Laguna Madre Water District
Wastewater Treatment Plants Rehabilitation
 September 2016

Isla Blanca WWTP
Site Plan And
Mechanical Modifications
To Existing Plant

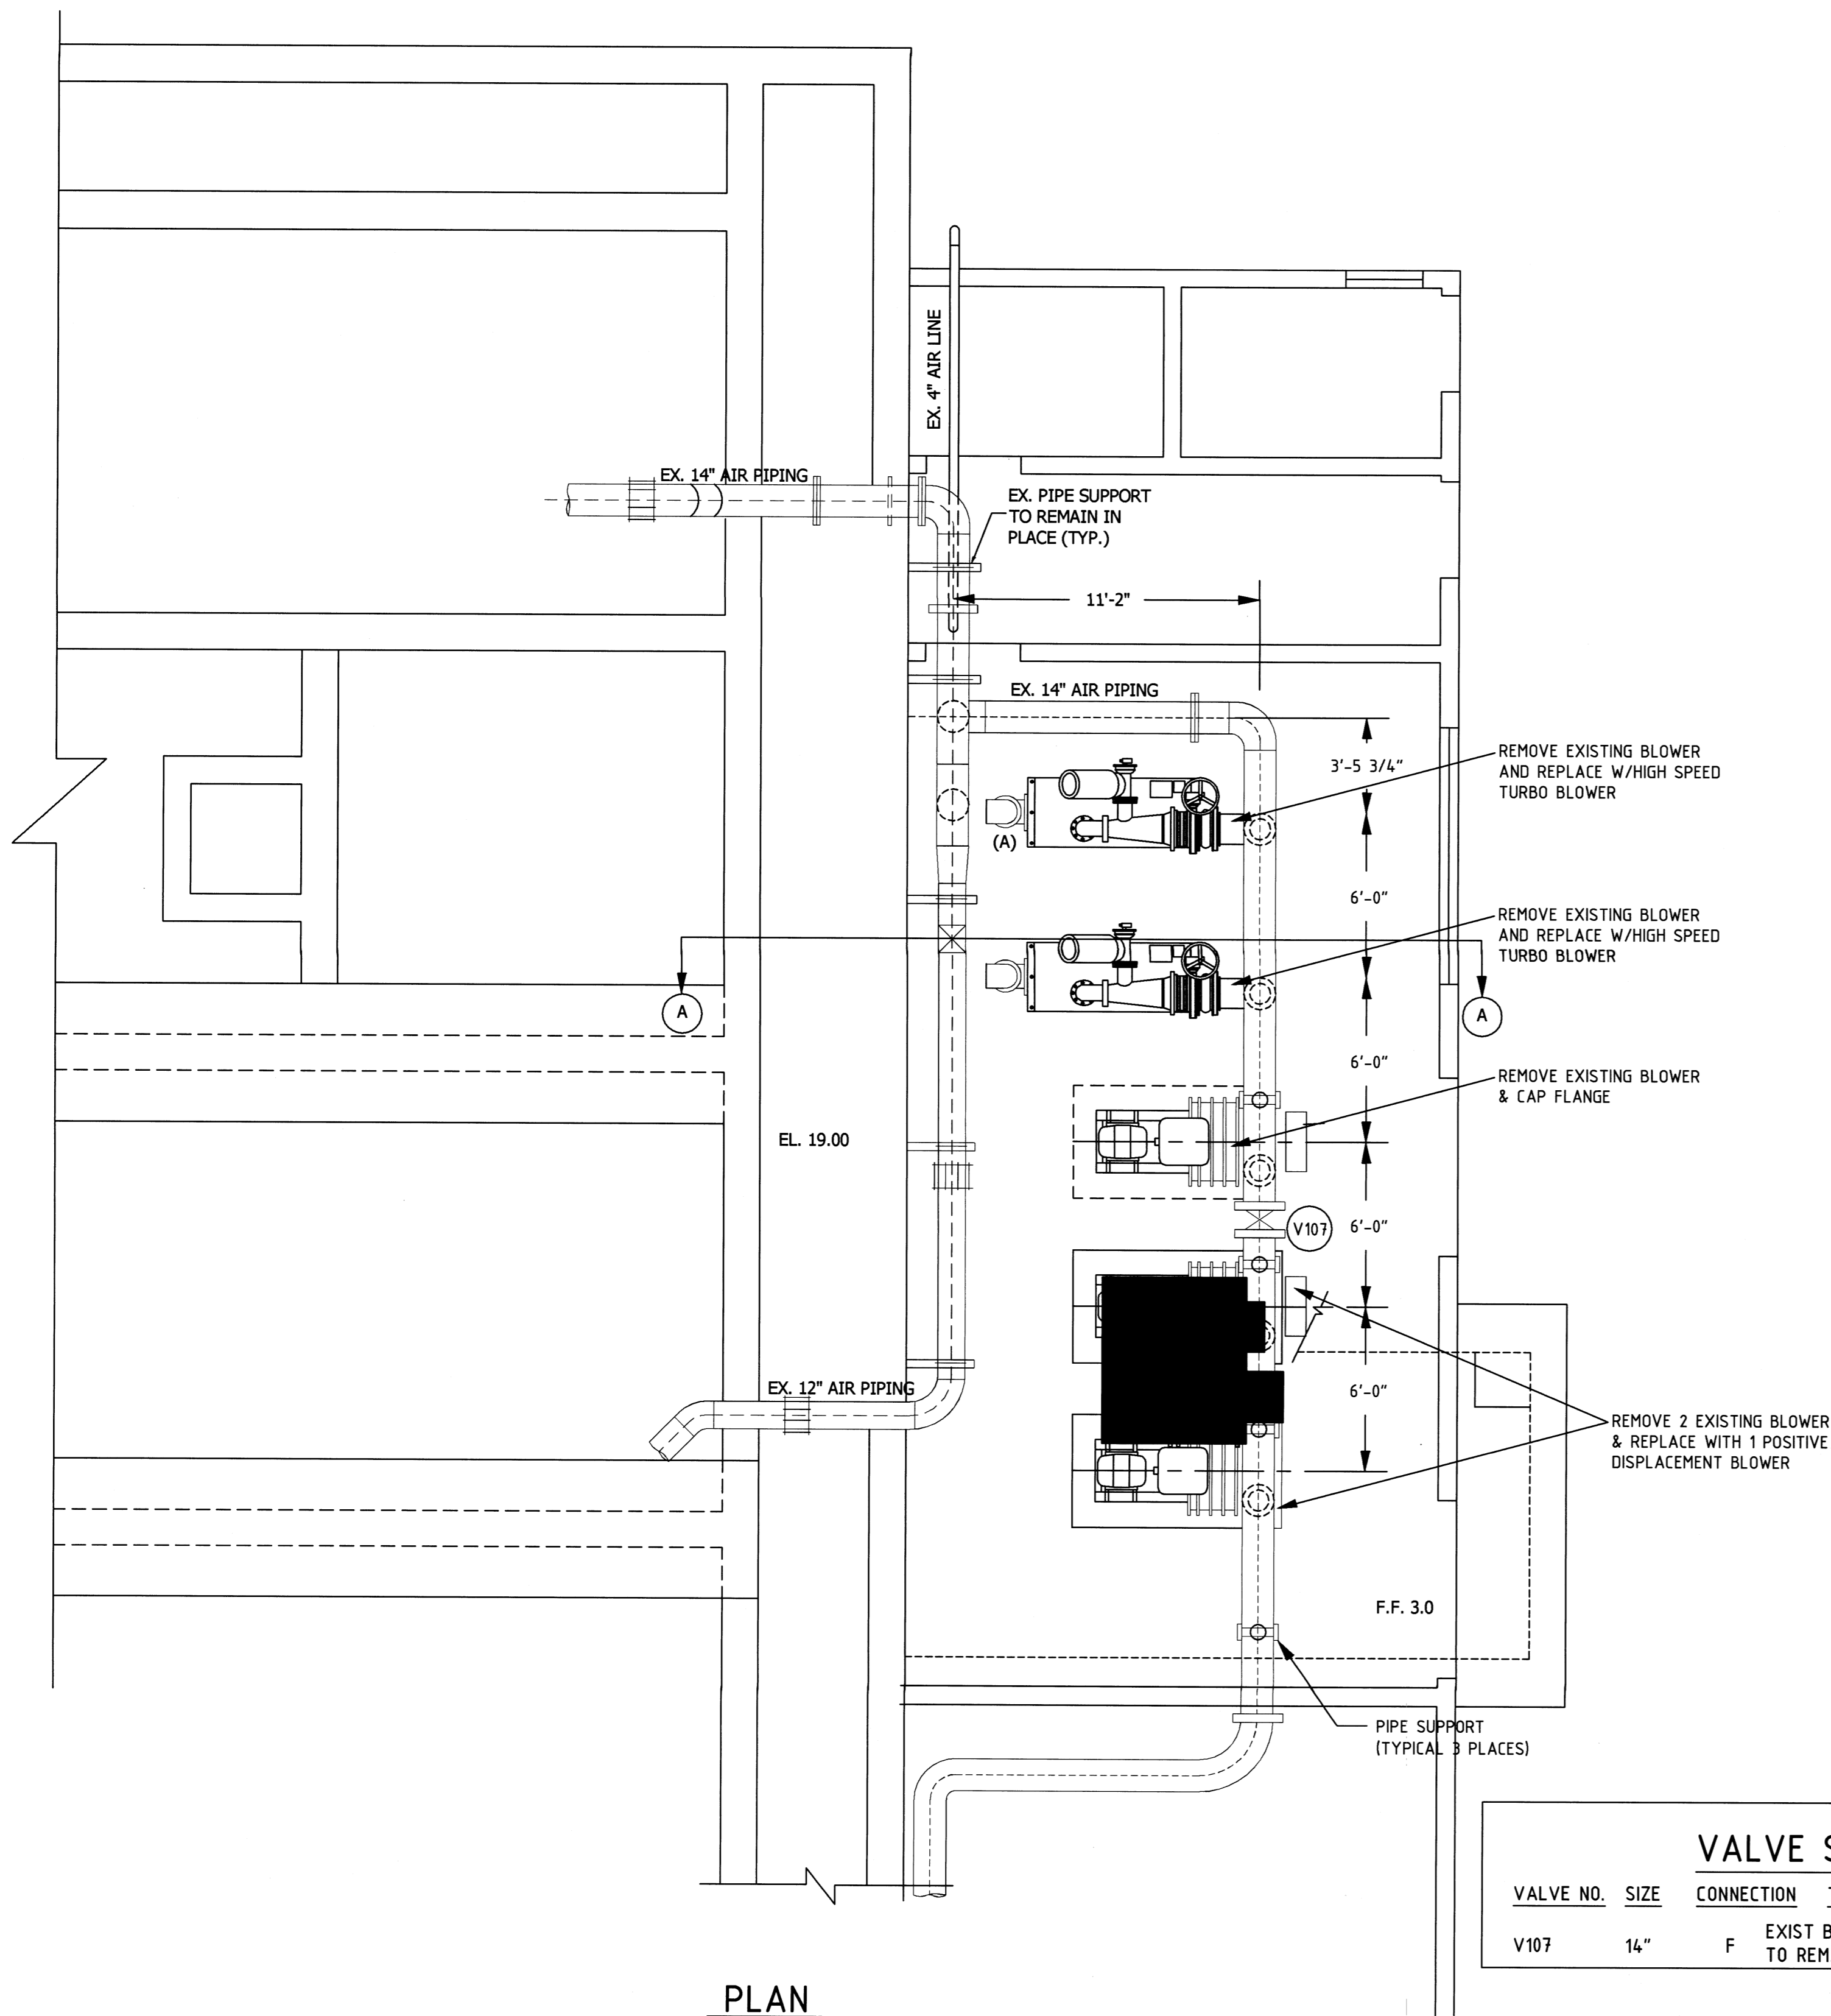
- NOTES**
1. REMOVE APPROXIMATELY 1,475 CY OF GRIT FROM EXISTING AERATION BASINS, INFLUENT CHANNEL, AND EFFLUENT CHANNEL. CONTRACTOR IS RESPONSIBLE FOR GRIT DISPOSAL.
 2. A SUFFICIENT AMOUNT OF GRIT MUST BE REMOVED TO RESTORE ALL FAILED AERATION ASSEMBLIES.
- ▲ ADDENDUM No.1: REVISED AIR SUPPLY MODIFICATIONS TO INCLUDE THERMAL MASS FLOWMETER, SPECIFIED SCHEDULE 40 FOR ALL AIR SUPPLY LINES.

PROFILE, SECTION A-A

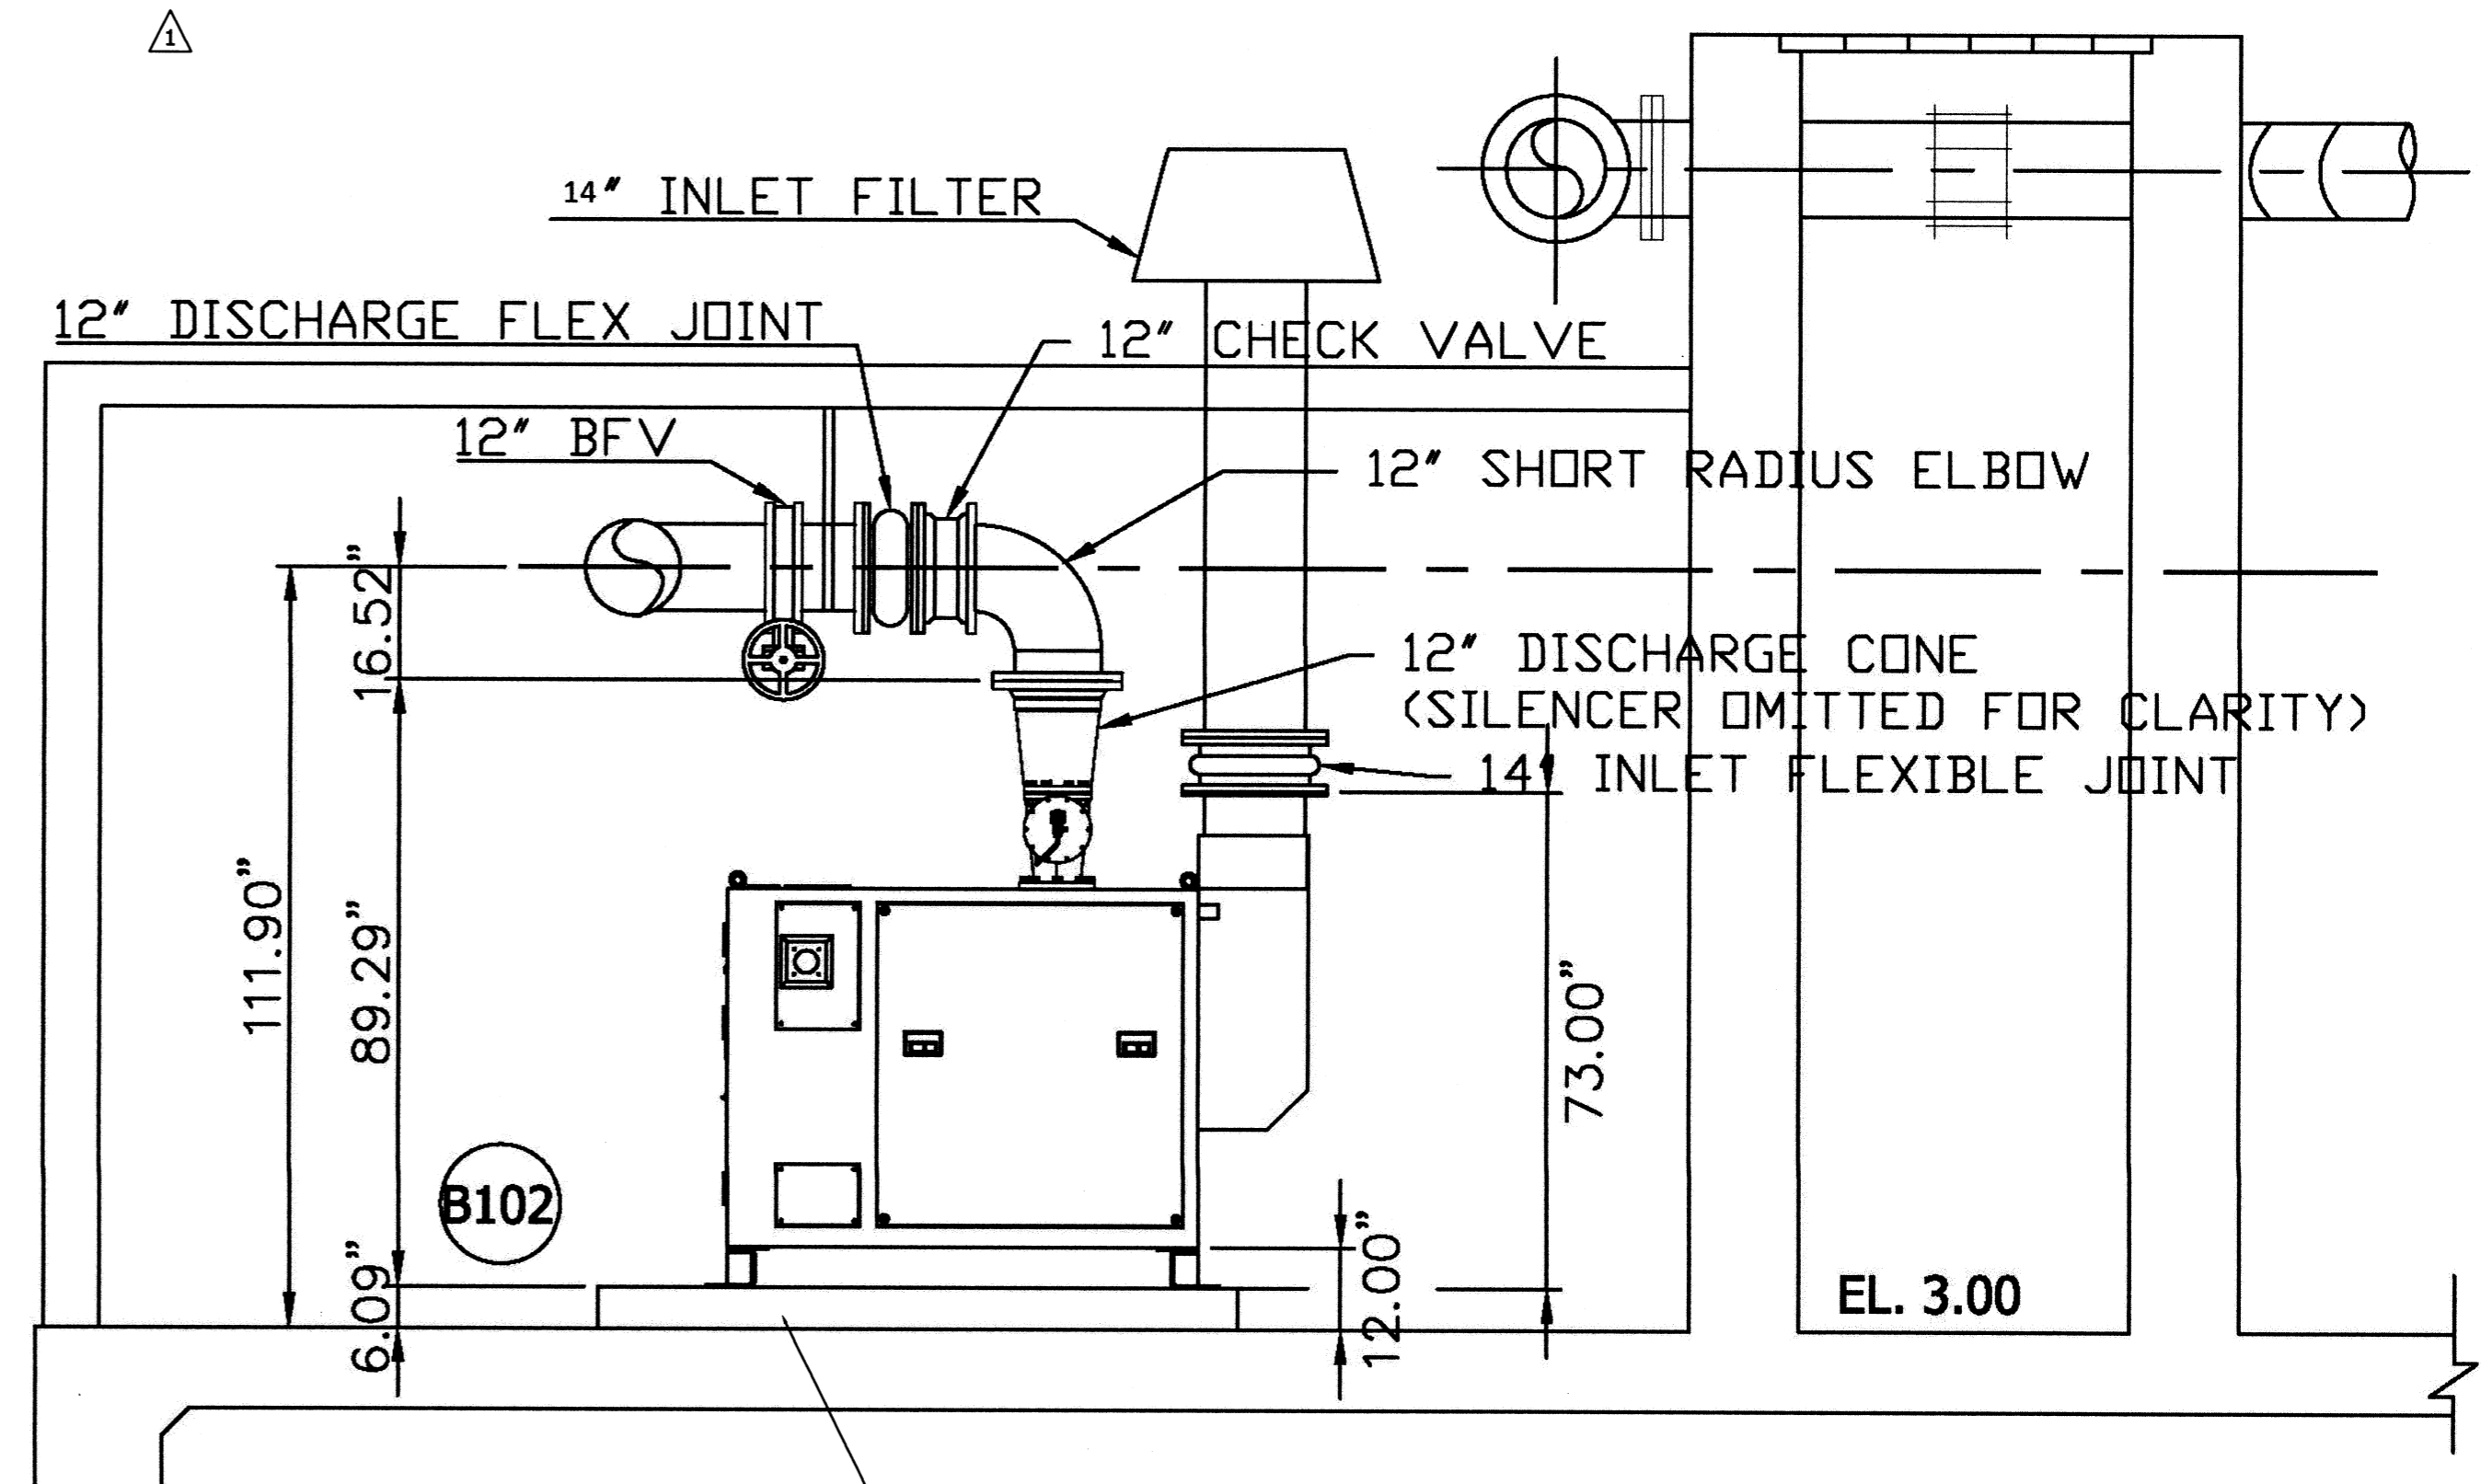
NOTES:
ADDENDUM No1: REVISED TURBO BLOWER PROFILE VIEW FOR BASE BID. BLOWERS MUST BE ELEVATED 12-INCHES ABOVE FINISHED FLOOR ELEVATION TO STAY ABOVE THE 100-YR FLOOR PLAIN.
